## **Access Compliance Report Public Rights-of-Way** (Curb Ramps)

Intersection ID: 10023016 Main Street: CENTER\_PARK\_DR **Cross Street: N/A** Location: NW ADA ID: FB78A7A39FE8 Ramp Type: PerpDiag Initial Pass/Fail: Fail **Overall Compliance: No** Severity Score: 21.25

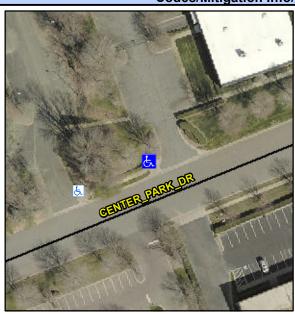
Street 1 Name Stop Condition-Street 2 Street 2 Name Stop Condition-Street 1 **CENTER PARK DR** None **ENTRANCE** None Possible Solutions: Remove & Replace Curb Ramp With **Two New Directional Ramps or** Equivalent. Surveyor Notes: N/A PROW/ADA: Not Found, R304.5.1, R304.2.2

Field Measurements/Component Compliance					
Compliance Description		Data	Comp	liance Description	Data
N/A	Ramp Length (in)	49.0	No	Ramp Slope (%)	10.2
No	Ramp Width (in)	44.0	Yes	Ramp XSlope (%)	2.0
N/A	Flare Type LT	N/A	N/A	Flare Type RT	N/A
N/A	Flare Slope LT (%)	N/A	N/A	Flare Slope RT (%)	N/A
N/A	Flare Traversable LT?	N/A	N/A	Flare Traversable RT?	N/A
N/A	Landing Length (in)	N/A	N/A	DWS Provided?	N/A
N/A	Landing Width (in)	N/A	N/A	DWS Contrast?	N/A
N/A	Landing Slope (%)	N/A	N/A	DWS Length (in)	N/A
N/A	Landing X Slope (%)	N/A	N/A	DWS Full Width?	N/A
N/A	Landing Curb? (Y/N)	N/A	N/A	DWS Offset (in)	N/A
N/A	Shared Landing?	N/A			
N/A	Gutter Ponding?	N/A	N/A	Gutter Slope (%)	N/A
N/A	Gutter Lip Ht (in)	N/A	N/A	Gutter X Slope (%)	N/A
N/A	Painted X Walk1?	No	N/A	Painted X Walk2?	No
	X Walk 1 Direction	To S		X Walk 2 Direction	To E
N/A	X Walk 1 Width (in)	N/A	N/A	X Walk 2 Width (in)	N/A
	X Walk 1 Slope (%)	1.3		X Walk 2 Slope (%)	0.2
